Engineering Report

**Armstrong & Kelman
 Lot 1 DP 382901
 Mahau Sound**

Request for Further Information - U071321 - Kelman, Joy May & Armstrong, John William - 292 Moetapu Bay Road Havelock

Resource Consent Application

smartalliances ENGINEERING / RESOURCE MANAGEMENT / ARCHITECTS TEL 03 579 6211 FAX 03 579 6233 PO BOX 546 BLENHEIM NEW ZEALAND	CLIENT ARMSTRONG KELMAN	PROJECT DWELLING SITE PLAN DRAWING WWTS	DWG NO. AMENDMENT
AMENDMENT DATE DETAILS	AMENDMENT DATE DETAILS		DATE 29/11/07	SCALE 1:500	CAD FILE REF: 0891

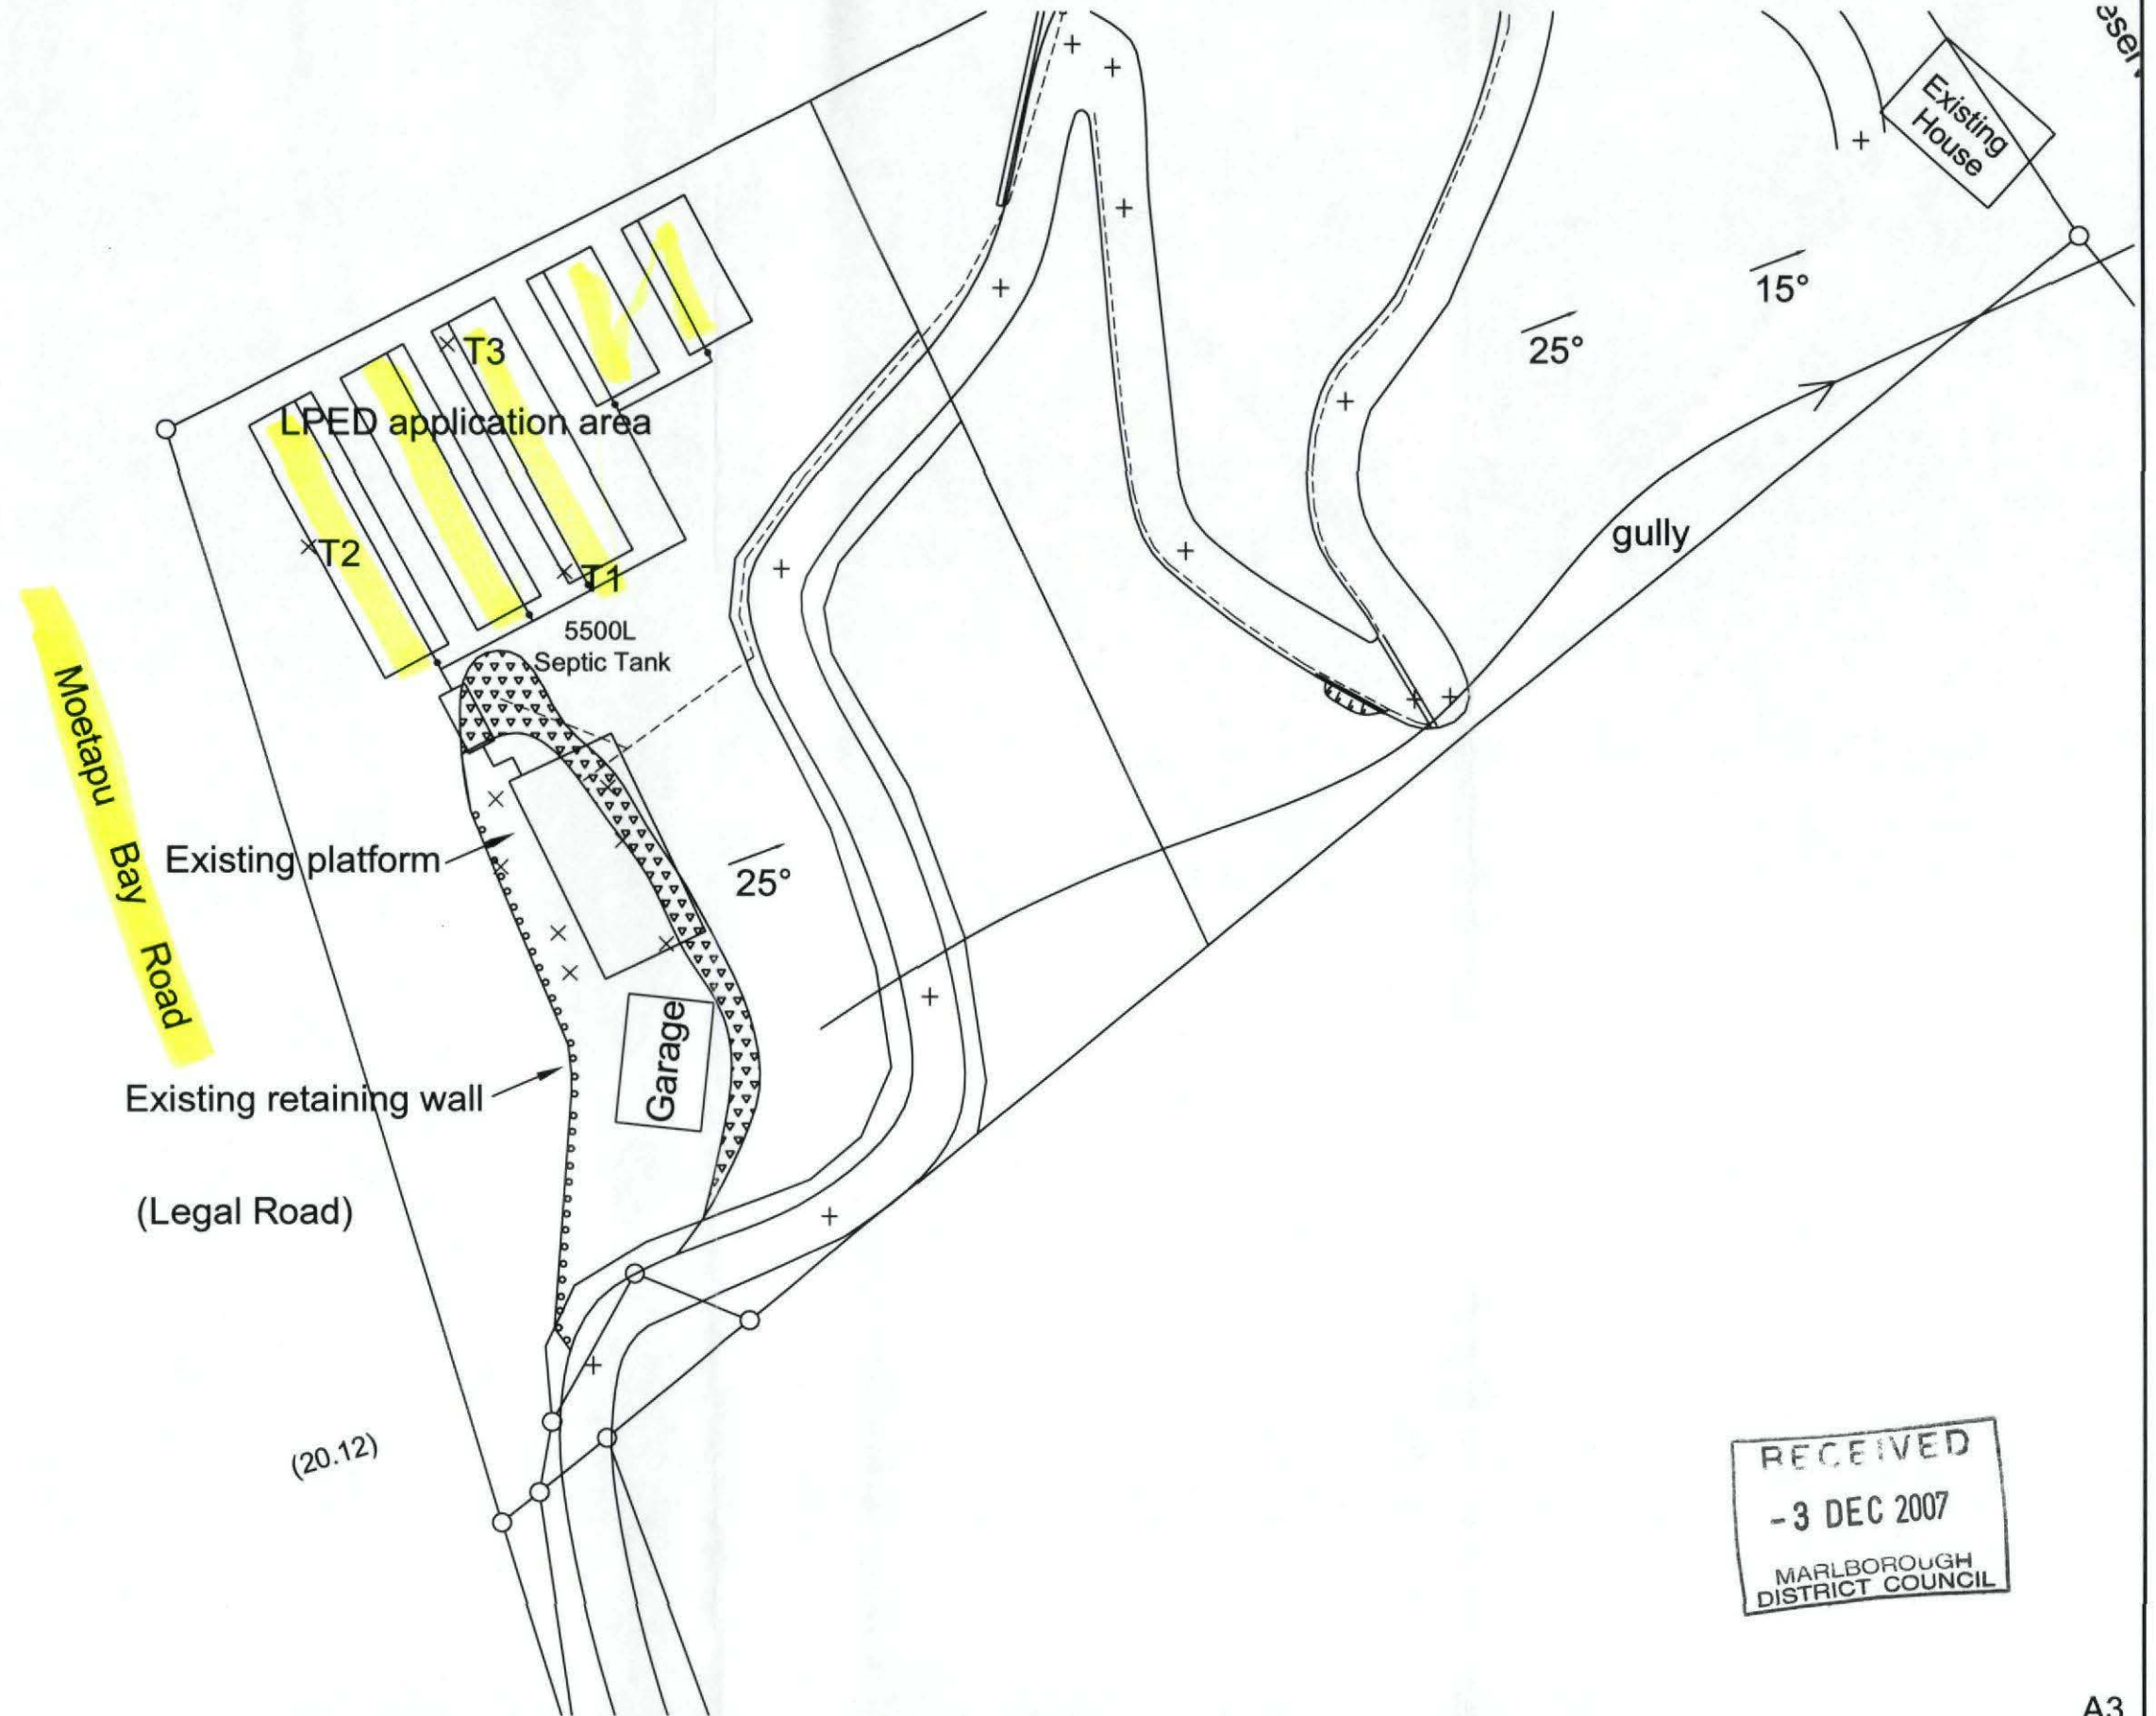
~~Four~~ - 20m x 5m LPED beds *2 10m x 5m LPED beds* *shillock*
TRILL
